Technical Bulletin No. IXO-001

SUBJECT: Service Manual Correction	DATE: June 14th, 1993
---	---------------------------------

This information includes corrections to the IXO service manual.

RICOH**Technical Bulletin No. IXO-002****SUBJECT:** The printer cover may not be closed.**DATE:**
July 14th, 1993

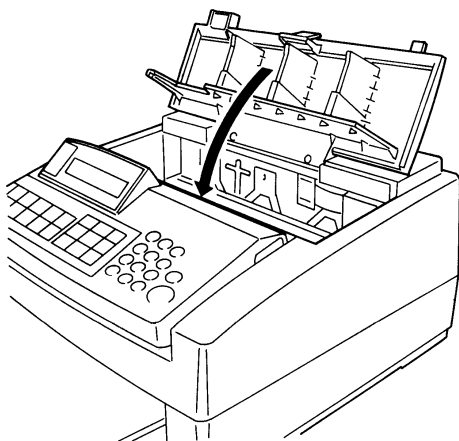
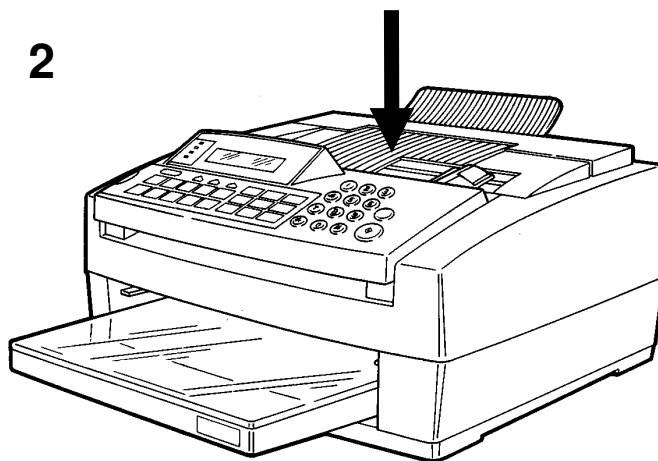
The printer cover may not be closed by pushing both eadges of the cover.
"CLOSE COVER" is displayed on the LCD continuously.

If you receive a complaint concerning this matter, please advise your customers to push the center when closing the cover.

SUBJECT: Notice for operation panel removal

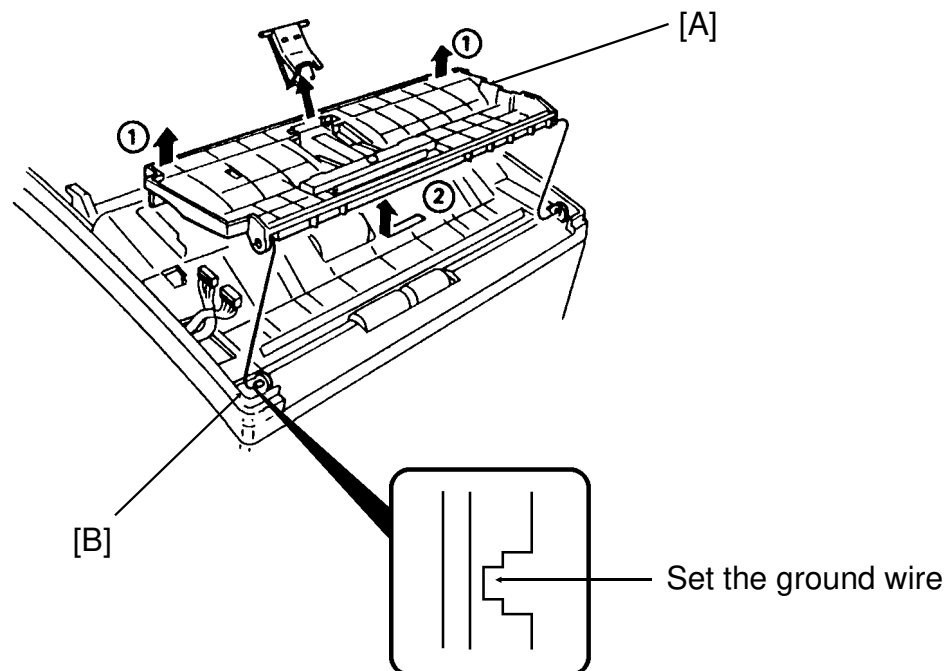
When removing the white pressure plate [A] of the operation panel assembly, set the ground wire into the recess in the upper cover and then slide out the white pressure plate. Otherwise, the scanner base pin [B] may be broken.

SUBJECT: How to put the spacers on the scanner.

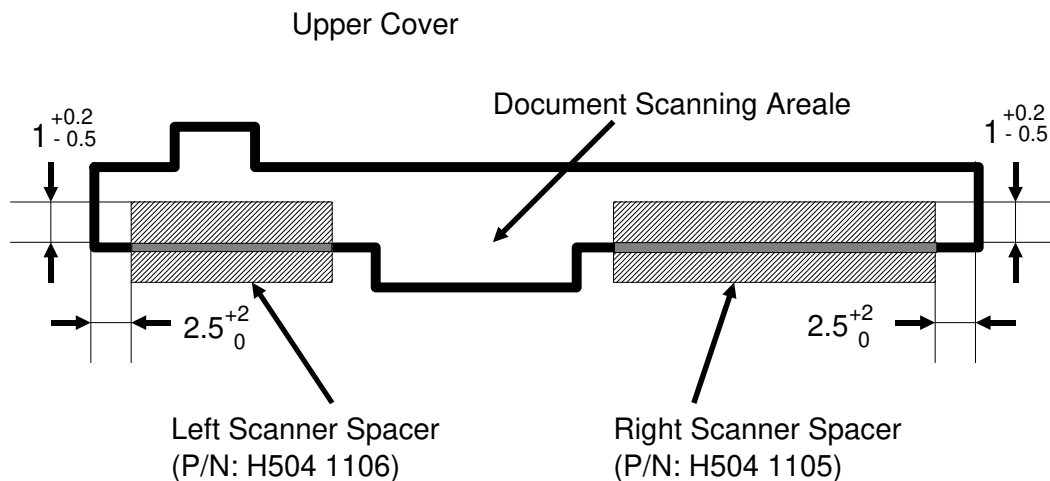
Attach the scanner spacers to the upper cover according to the following procedure when replacing the cover.

1. Attach the two scanner spacers to the upper cover as shown below.

2. Ensure that the distance between the spacers and the pressure plate is more than 0.2mm by using a thickness gauge.

SUBJECT: Back to Back Test

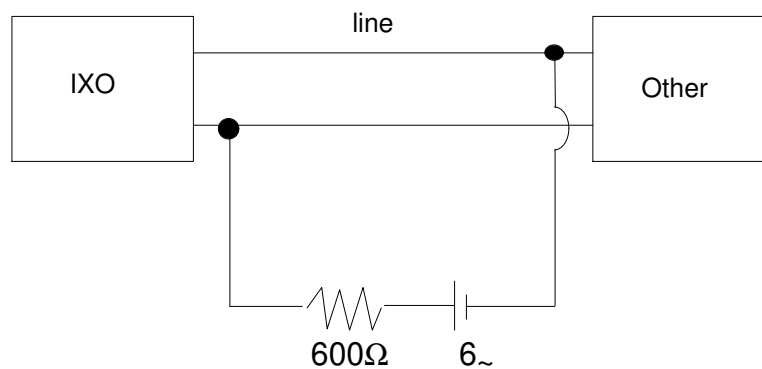
Photocouplers are used instead of mechanical relays on the NCU for IXO.

When you test back to back communication using IXO, pass current on the line as follows.

Cassette Cover

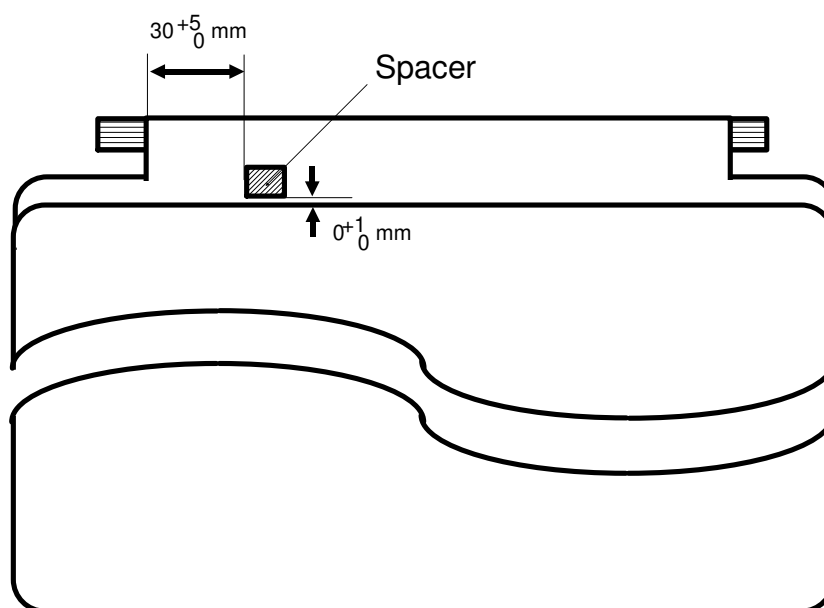
Symptom : If the operator puts a sheet of paper on the cassette cover, the machine may pick up the paper and print on the back.

Cause : The edge of the paper reaches the feed roller if the paper is inserted far enough into the machine.

Countermeasure : A spacer has been attached to the cassette cover from March production so that the paper does not reach the roller.

Action in the field : Attach the spacer (P/N:H5044126) to the following position on the cover.

SUBJECT: Abnormal Paper Feeding

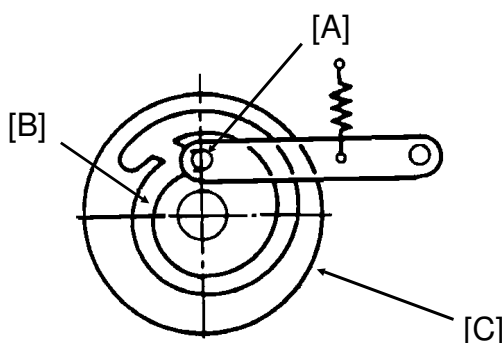
Cause: The lever [A] of a certain lot is defective. The pin of the lever comes off the notch [B] of the paper feed cam [C] and the feed roller does not stop at the home position .

A spacer has been attached to the inside of the cover on the production line for the applicable lots so that the lever does not come off.

Modify the machine by attaching the spacer according to the modification procedure if you have any complaints from the customers.

Inside the base on the right-hand side

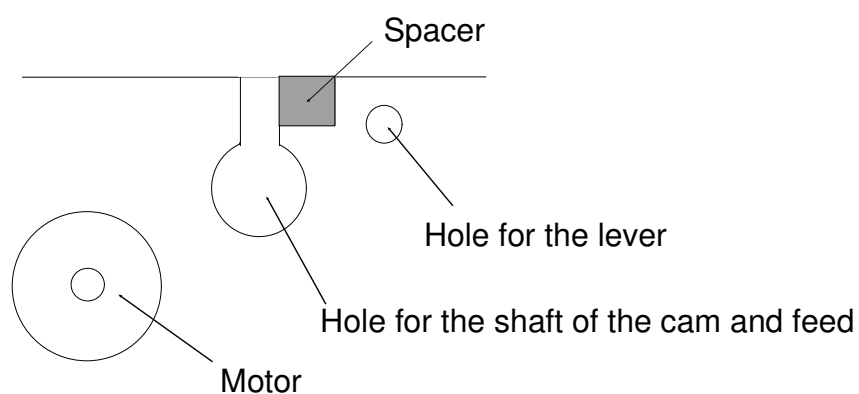
1. Remove the op-port ass'y.
2. Remove the upper cover.
3. Attach the spacer to the inside of the base as shown below.

SUBJECT: Ink end detection

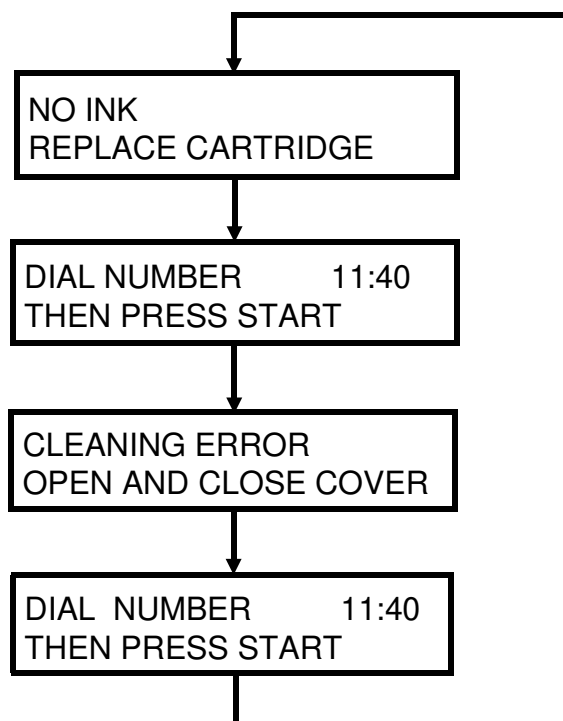
After the machine detects ink end, if the user changes an ink cartridge (detected when the printer initializes such as when opening and closing the cover, or removing and resetting the cassette), the software has been changed so that the machine works as follows.

According to this modification, the display on the LCD has been changed during ink end detection as follows.

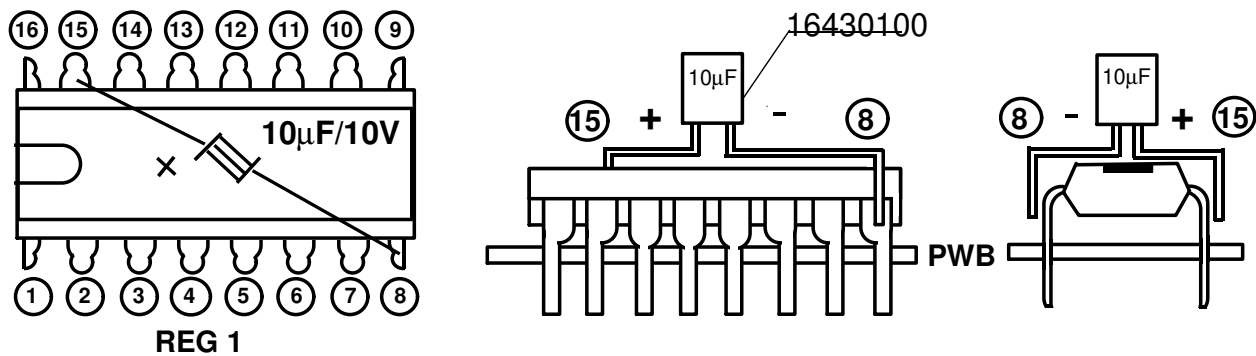
Problem: No print or blank copy with NO INK displayed.
Turning main power OFF/ON is required for recovery.

Cause: The 24V supply from the DC/DC converter on the FDU to the printer unit stops when the voltage of the main power drops to about 50% for more than 440ms. If the power loss is more/less than or of a shorter duration than the above, 24V is supplied properly after the power is back to normal.

Countermeasure:
Put a capacitor (10μf, 10V) between pin #8 and #15 of the IC REG1 on the FDU.
